## 626 HEIDELBERG ROAD, ALPHINGTON THE VILLAGE, ALPHINGTON (AMCOR PAPER MILLS PRECINCT – STAGES 2A AND 2B)

Urban Design Referral

<b>Date</b>	15 March 2019
<b>Council reference</b>	PLN17/0703.01
<b>To</b>	Amy Hodgen
<b>From</b>	Mark Sheppard, David Lock Associates

*Extract of North Elevation showing recommended additional clear windows to supermarket*

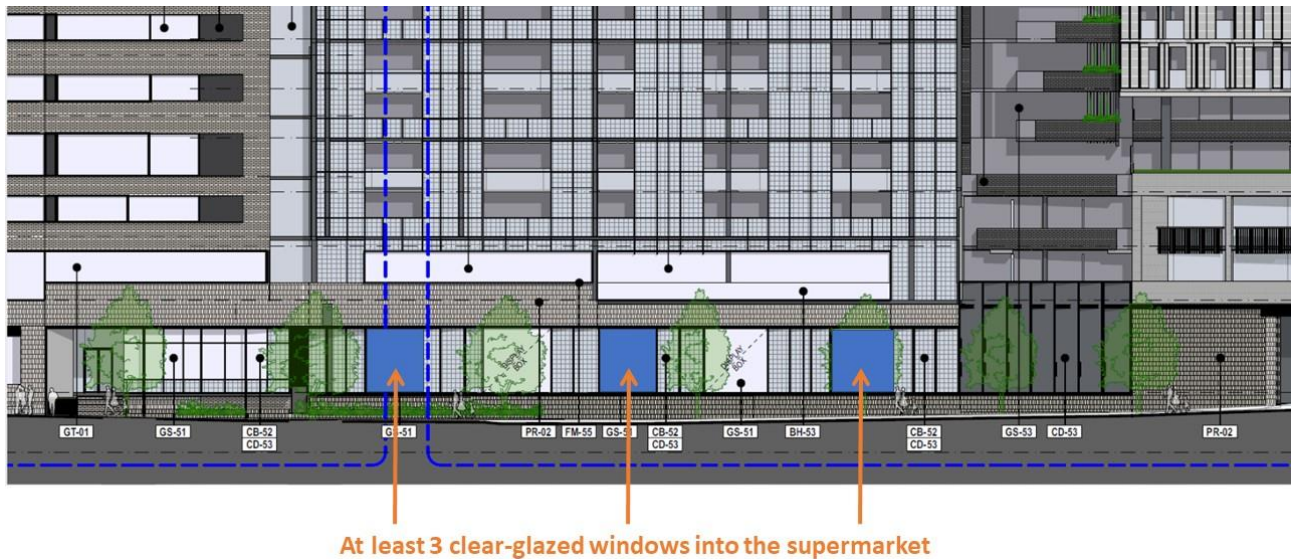
The amended permit proposal has a completely redesigned supermarket façade to Heidelberg Road, including substantially more ‘full height glazing’. However, all but one of these windows is to a display box, or comprises glass blocks, which will not provide visual connectivity. It is not considered that this meets the intent of condition 1(c) or the DP.

However, it is recognised that developing a supermarket with a fully-glazed external wall is challenging. Therefore, it is recommended that permit condition 1(c) be retained but changed to require at least 3 of the five proposed full-height windows to provide a clear view into the supermarket, with the window

dimensions generally retained and the clear windows distributed relatively evenly along the supermarket wall.
